Massachusetts Institute of Technology

May 29, 2002

To: MIT XIS Team
From: Mark Bautz
Subject: Summary of Charge Injection Review Meeting

Figure 1: Input gate driver circuit from Ed Boughan's email of 24 May; desirable changes to this circuit are discussed in the text

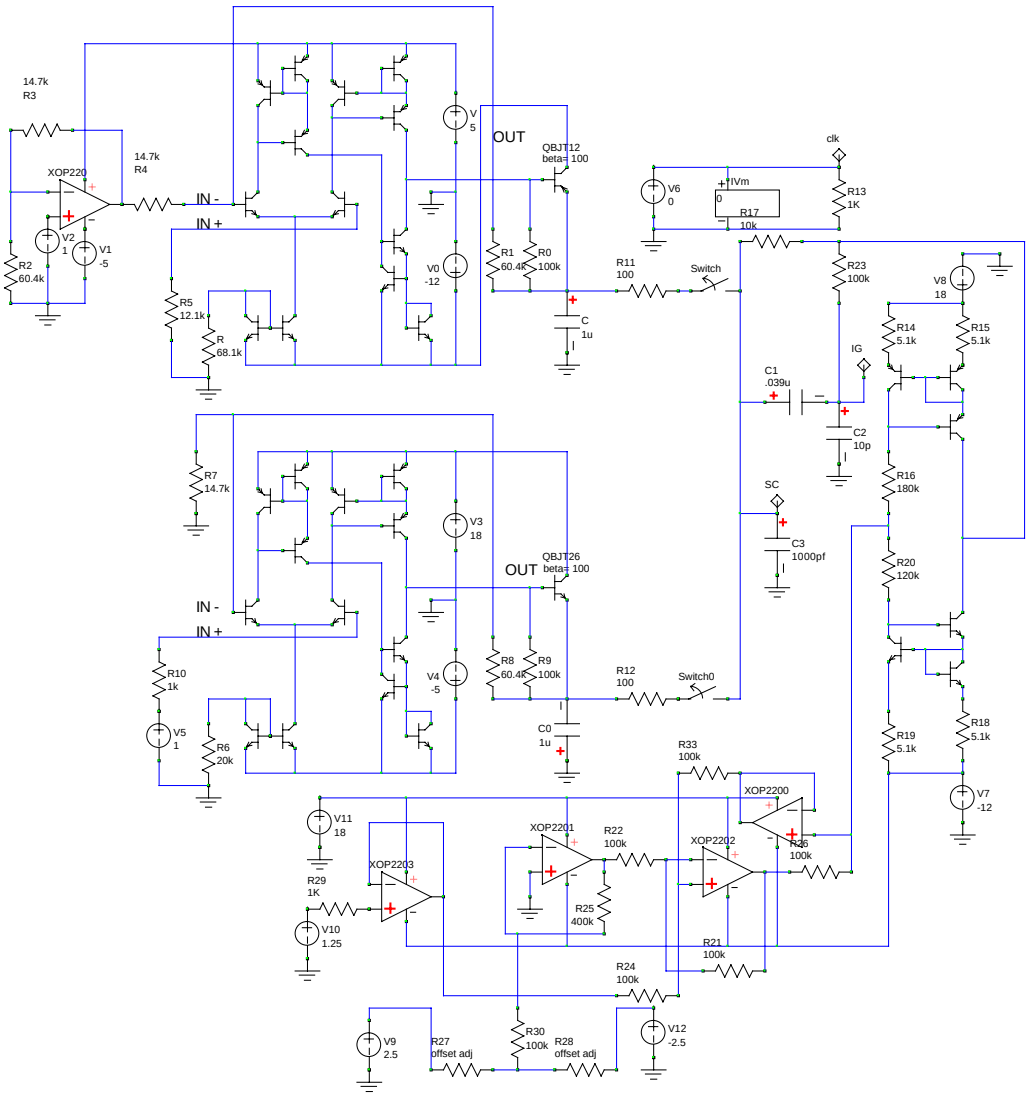
- We agreed that the input gate driver circuit (see Figure 1) was acceptable with the following stipulations:
  - ⋆ *Offset resistor locations:* Provision will be made to mount the coarse offset adjustment resistors (R27 and R29) on new, a sensor-specific external connnector on the AE/TCE box. We'll have one such connector for "side" of the AE. This will allow us to adapt the coarse offset adjustment to each sensor base by simply attaching a suitable external connector. Ed will work out details.

- ⋆ *Coarse adjustment range:* As currently drawn, the circuit provides a coarse offset adjustment range of about $\pm 1V$. John believes changes in passive component values can increase this to ± 2 V without affecting the resolution of the fine adjustment. John will investigate and propose changes to Ed to obtain a ± 2 V range.

- *The input diode bias* will be adjusted only via a DAC (not by sequencer driven clock signal.) To defeat charge injection we will set the ID potential high, via a dedicated DAC, (to +12 V or higher). To enable charge injection we will set the ID to a fixed operating point (approximately 6 V or so). With the ID at this operating point, we will control which lines contain injected charge by stopping and starting the serial register.

- *Input register transfer direction:* The input register clocks will be taken from the serial register clocks. The connections will be made so that, when the output register is clocking in the normal mode for taking science data, the input register will be clocking charge backwards (i.e. toward the input diode.) To inject charge, therefore, we will run the output register backwards. *This is a change from our agreement at the meeting.* The intent of this arrangement is to reduce the risk that charge would be injected inadvertently in the event that a DAC failure makes it impossible for us to to run the ID to a sufficiently high bias. To summarize, we want the input register to be moving charge in the same direction as output registers serving output nodes A and C.

- *Two additional telemetry channels* will be instrumented for the charge injection circuitry, as follows. (This will leave one remaining unused channel.)

- ⋆ Input diode bias.
  - ⋆ Input gate current (details TBD by John Doty).
- *The input gate driver test sequence* is to be as follows:
  - ⋆ Breadboard test complete by MIT XIS PDR. Will verify IG-to-S3 offset command capability, with ~ 300 mV precision.
  - ⋆ Laboratory "daughterboard" for use with calibration GSE in building 37 by early July.

- John Doty to suggest to Ed Boughan IG driver changes to allow $\pm 2V$ coarse adjustment.
- John Doty to define telmetry requirements and approach for input gate current.
